**Re: VJW Storage, Inc., 4800 McMahon Blvd. NW, Drainage & Grading Plan
Engineer's Stamp dated: 12-06-07 (A-12/D008A)**

Re: VIW Storage Drainage Analysis, City Project No. 771884, ZAP A-12
 Engineer's Stamp Dated December 6, 2007

CITY OF ALBUQUERQUE PUBLIC WORKS DEPARTMENT ENGINEERING GROUP		RECEIVED DEC 17 2007 HYDROLOGY SECTION	
VJV STORAGE INC OVERALL GRADING AND DRAINAGE PLAN			
Design Review Committee	City Engineer Approval	Mo./Day/Yr.	Mo./Day/Yr.
City Project No. 7718.84	Zone Map No. A-12	Sheet 5	Of 22

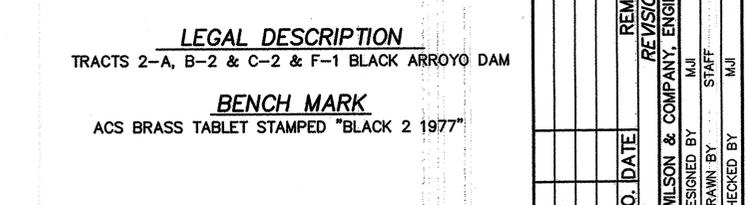
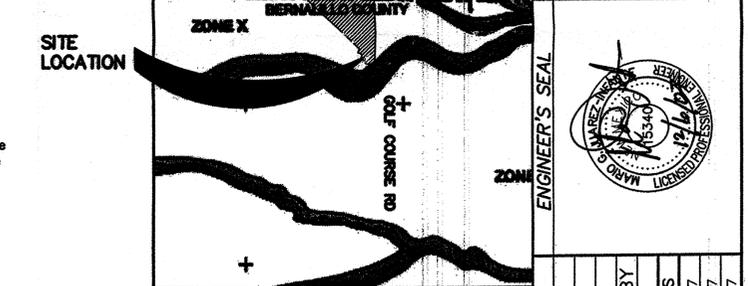
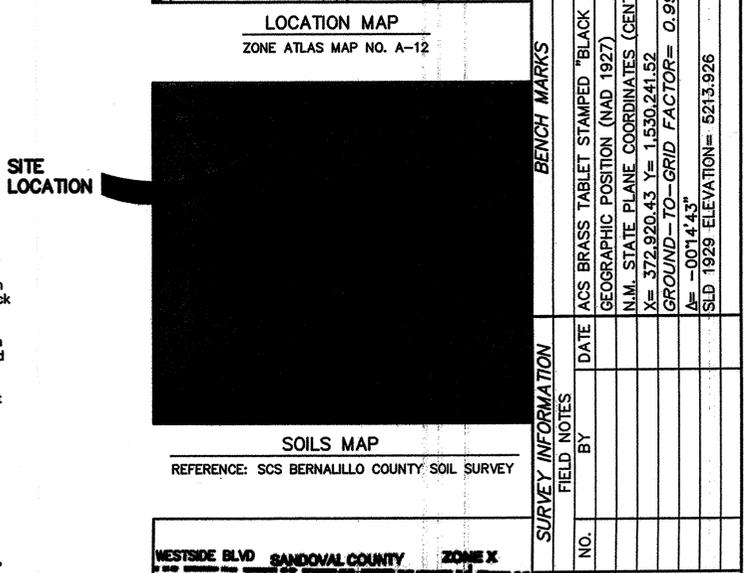
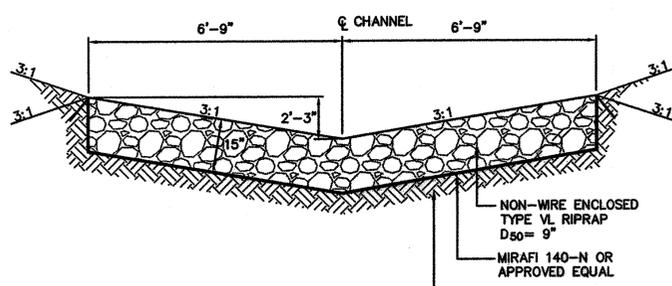
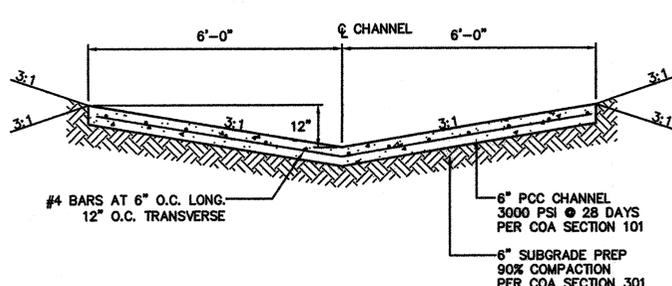
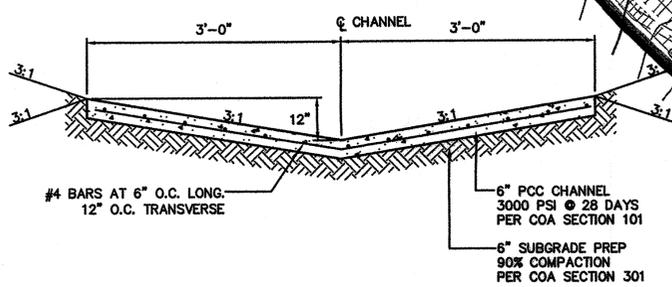
- Albuquerque
New Mexico 87103
www.cabq.gov
1. The Building Permit Plan that was submitted, dated 12-16-07, appears to be the same as the Approved Rough Grading Plan dated 12-16-07. Was this submittal received in error?
 2. What are the finished floor elevations of the storage units; as well as, the over all elevations for the site?
 3. Please provide the retention pond calculations.
 4. Identify what will be constructed under a work-order and what will be constructed with a building permit.
 5. Please resubmit a constructible set of plans with a scale of 1" to 20'. The submitted plans will need to be certifiable.
